Wisconsin Department of Transportation

<p>Proposal #21: 1120-57-60, WISC 2024010 Neenah - Appleton Breezewood - STH 15 IH 41 Winnebago and Outagamie County</p>	<p>1517-14-71, WISC 2024013 V Fox Crossing, USH 10 Cold Spring Rd N-70-0009 USH 10 Winnebago County</p>
---	--

Letting of November 14, 2023

This is Addendum No. 01, which provides for the following:

Addendum No. 01
ID 1120-57-60
Revised Sheet 20
November 9, 2023

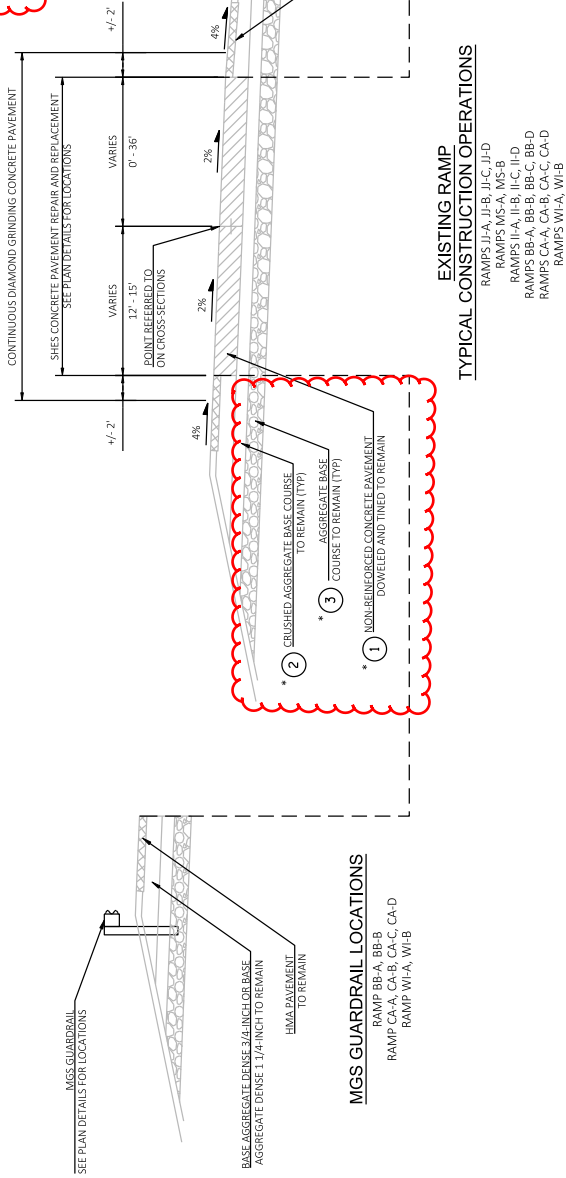
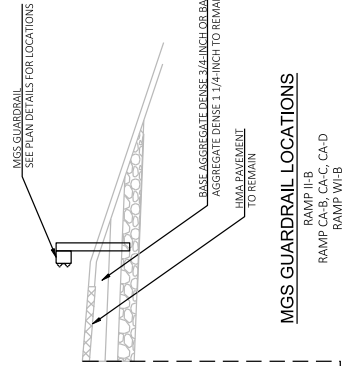
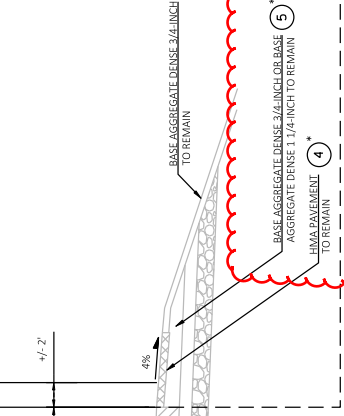
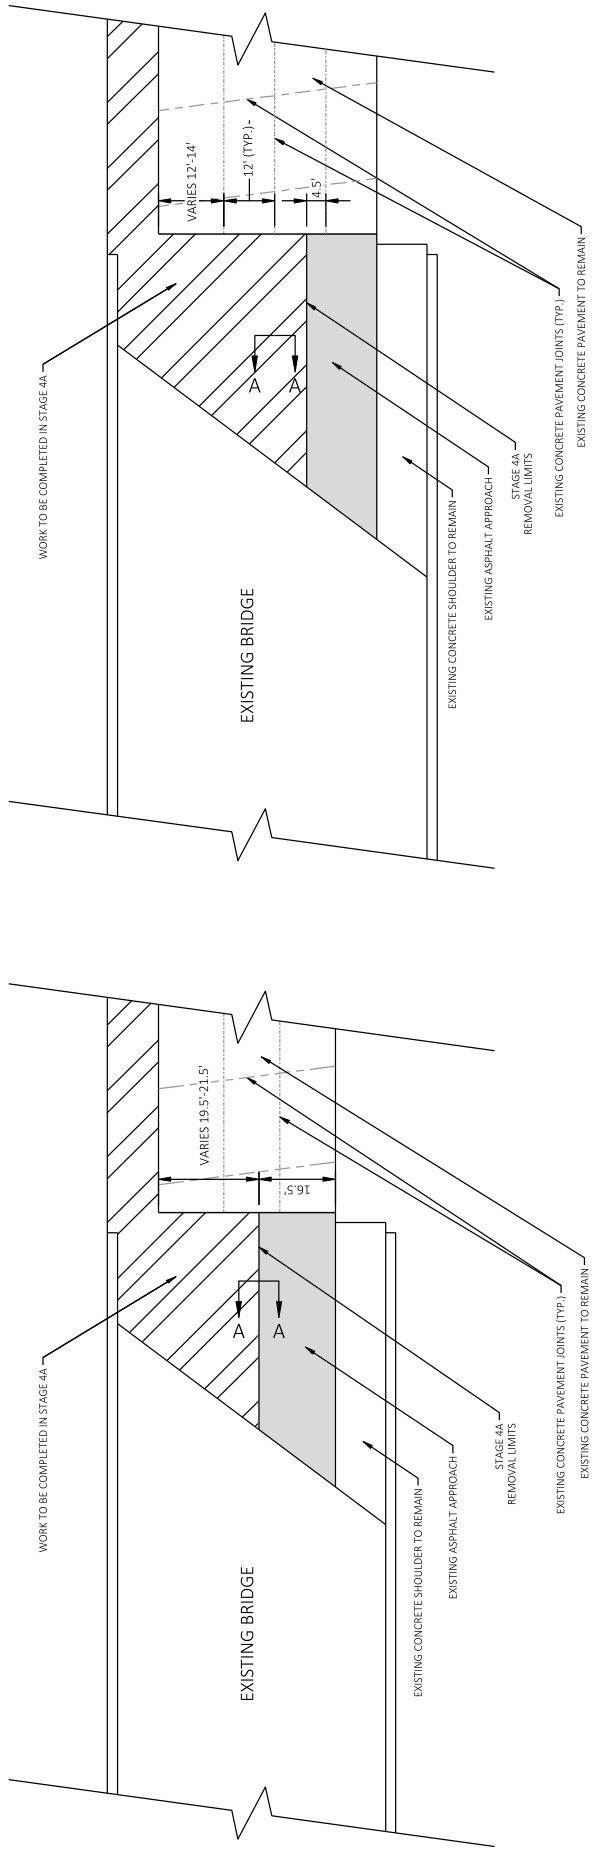
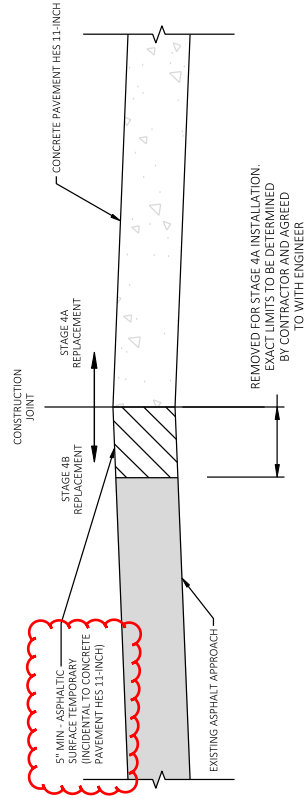
Revised Plan Sheets	
Plan Sheet	Plan Sheet Title (brief description of changes to sheet)
20	Construction Details: Added table to provide pavement depths for ramps.
137	Traffic Control - Construction Details: Added a note to clarify that Asphaltic Surface Temporary is incidental to bid item Concrete Pavement HES 11-inch.
557 & 559	B-70-129 130 Quantity change
586 & 587	B-70-132 Superstructure Details

RAMP	(1)	(2)	(3)	(4)	(5)
J1-A	12"	4"	6"	3.5"	8.5"
J1-B	12"	4"	6"	3.5"	8.5"
J1-C	12"	4"	6"	3.5"	8.5"
J1-D	12"	4"	6"	3.5"	8.5"
MS-A	10"	4"	6"	3.5"	6.5"
MS-B	10"	4"	6"	3.5"	6.5"
II-A	12"	4"	6"	3.5"	8.5"
II-B	10"	4"	6"	3.5"	6.5"
II-C	12"	4"	6"	3.5"	8.5"
II-D	12"	4"	6"	3.5"	8.5"
BB-A	10"	4"	6"	3.5"	6.5"
BB-B	10"	4"	6"	3.5"	6.5"
BB-C	10"	4"	6"	3.5"	6.5"
BB-D	10"	4"	6"	3.5"	6.5"
CA-A	10"	4"	6"	3.5"	6.5"
CA-B	10"	4"	6"	3.5"	6.5"
CA-C	10"	4"	6"	3.5"	6.5"
CA-D	10"	4"	6"	3.5"	6.5"
WI-A	10"	4"	6"	3.5"	6.5"
WI-B	10"	4"	6"	3.5"	6.5"

* THICKNESS PROVIDED IN TABLE ABOVE.

Addendum No. 01
ID 1120-57-60
Revised Sheet 559
November 9, 2023

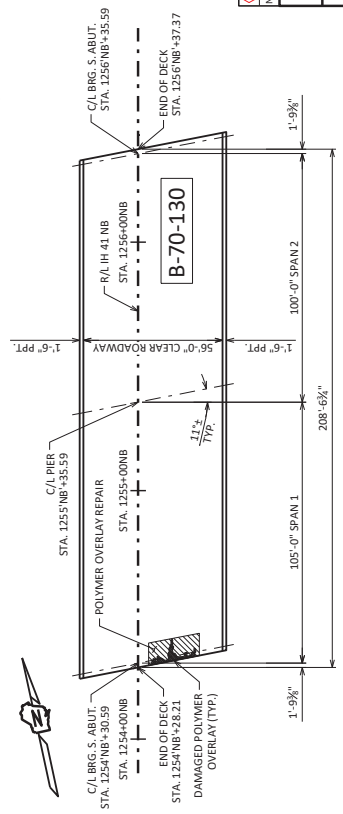
NO.	DATE	REVISION	BY
1	11/09/23	B-70-130 QTY. CHANGE	RRH
STATE OF WISCONSIN DEPARTMENT OF TRANSPORTATION STRUCTURES DESIGN SECTION			
STRUCTURE B-44/70-VARIES		DRAWN BY RRH	CHECKED BY DLM
B-70-130/133/134/135/ 136/210/400/401/402/ 405/407/409 REPAIRS		SHEET 3	559

BID ITEM	DESCRIPTION	COMMENTS
502.3205	PIGMENTED SURFACE SEALER RESEAL	APPLY TO FRONT FACE AND TOP FACE FOR FULL LENGTH OF BOTH PARAPETS
509.1500	CONCRETE SURFACE REPAIR	REPAIR SPALLING AT NE CORNER ABUT.
509.1500.5	POLYMER OVERLAY	REPLACE POLYMER OVERLAY AT S END OF DECK
509.9015.5	REMOVING POLYMER OVERLAY AT S END OF DECK	REMOVING POLYMER OVERLAY AT S END OF DECK
SPV.0090	JOINT SEALING	DECK SEALING - NOT USED
SPV.0180	METHACRYLATE FLOOD SEAL	DECK SEALING

Addendum No. 01
ID 1120-57-60
Revised Sheet 586
November 9, 2023

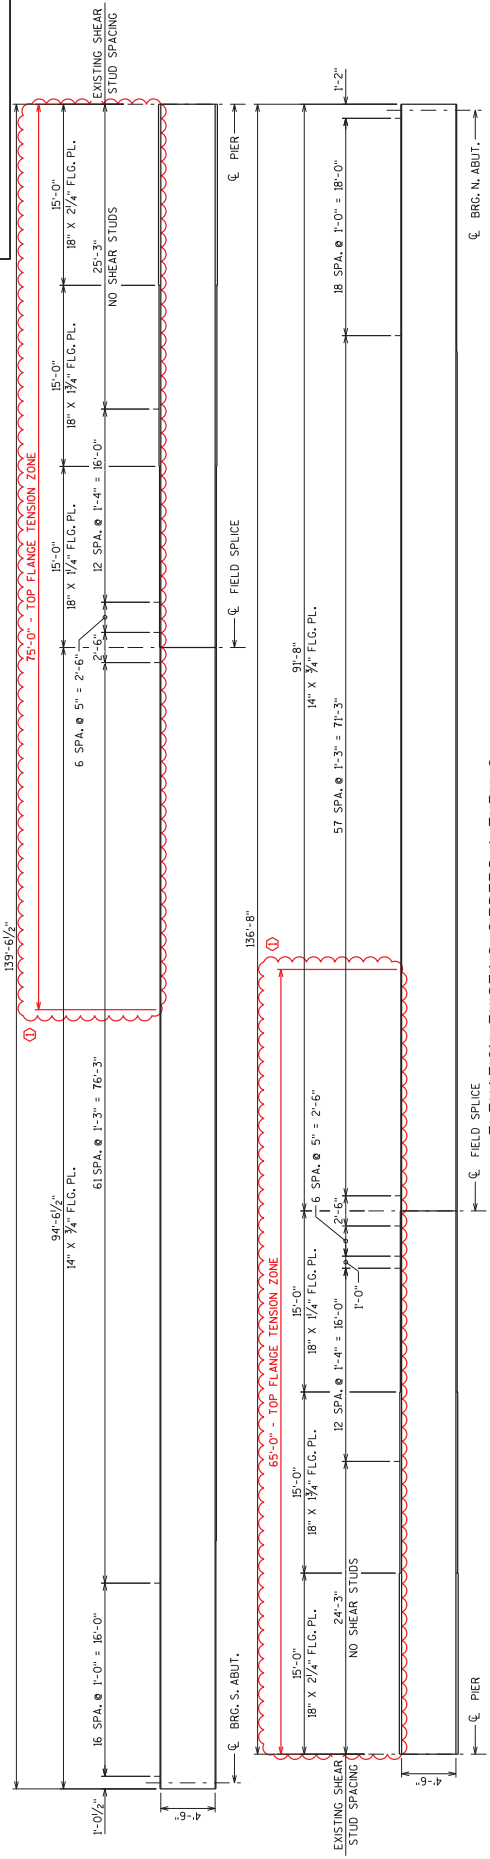
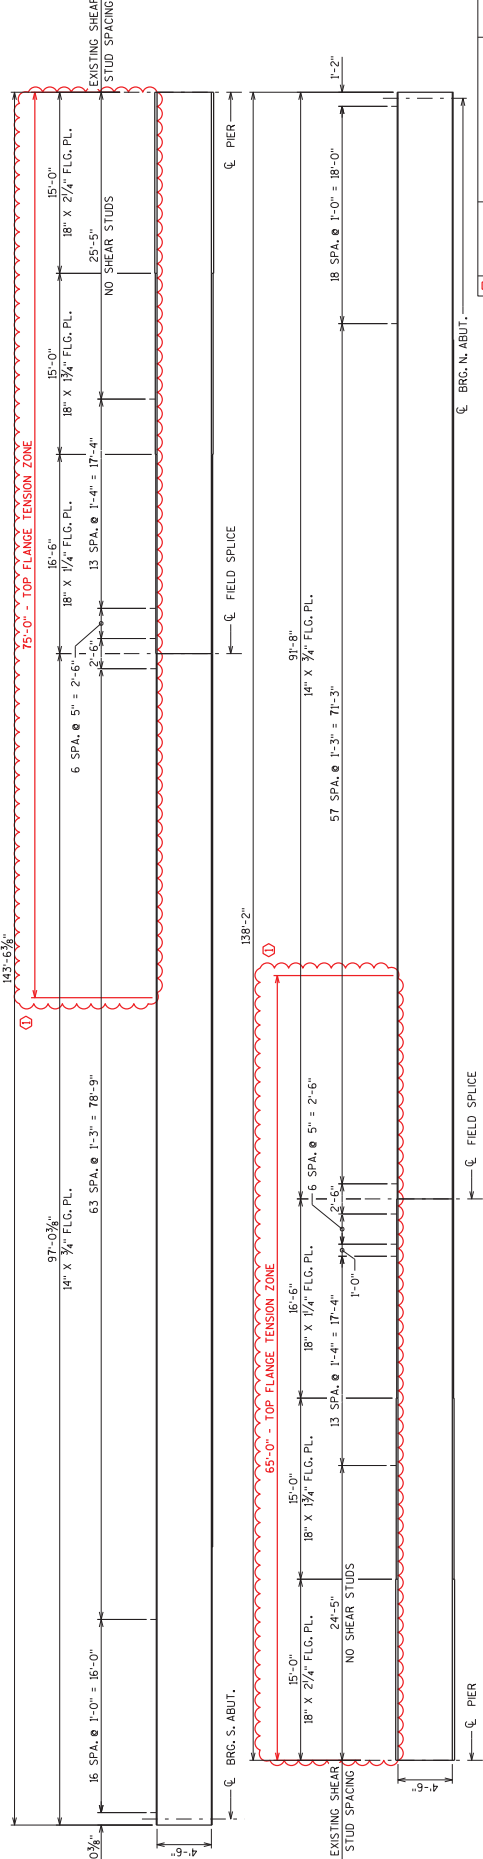
NOV/2023	TENSION ZONES	JLR
NO. DATE	REVISION	BY
STATE OF WISCONSIN DEPARTMENT OF TRANSPORTATION STRUCTURES DESIGN SECTION		
STRUCTURE B-70-132		
BR/MN	JLR	PLANS
BR	CK/D	LMK
SUPERSTRUCTURE DETAILS 1		
SHEET 14		
586

NOTE: DO NOT FIELD WELD WITHIN THE TOP FLANGE TENSION ZONES

Addendum No. 01
ID 1120-57-60
Revised Sheet 587
November 9, 2023

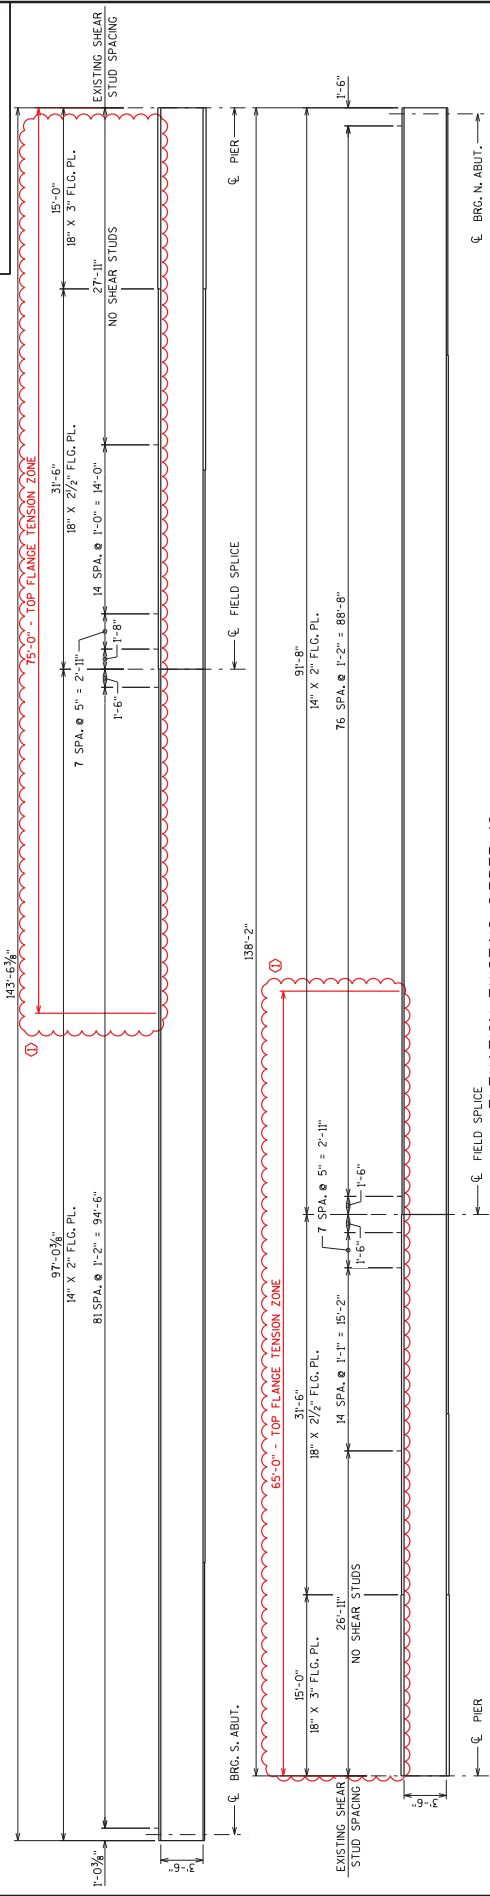
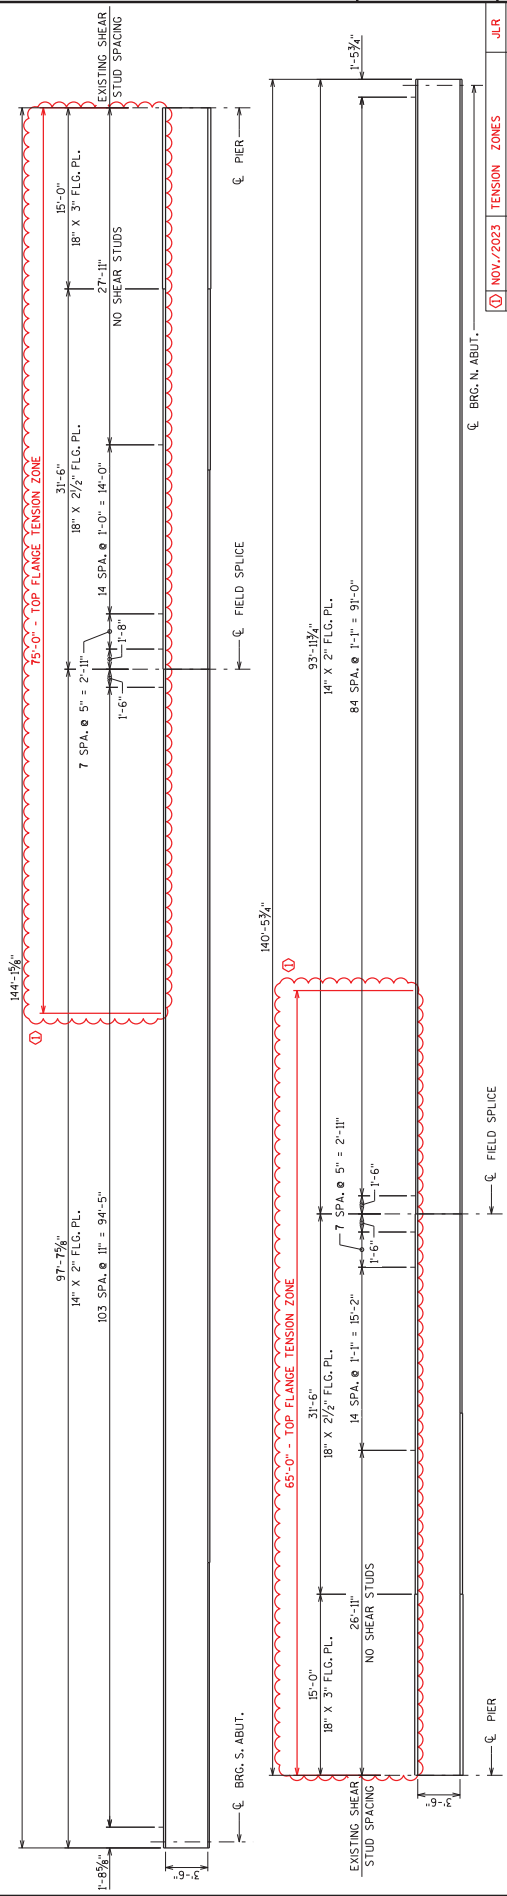
NOV/2023	TENSION ZONES	JLR
NO. DATE	REVISION	BY
STATE OF WISCONSIN DEPARTMENT OF TRANSPORTATION STRUCTURES DESIGN SECTION		
STRUCTURE B-70-132		
BR/MIN	JLR	PLANS
BR/MIN	JLR	CHKD.
SUPERSTRUCTURE DETAILS 2		SHEET 15
		587

Ⓢ NOTE: DO NOT FIELD WELD WITHIN THE TOP FLANGE TENSION ZONES
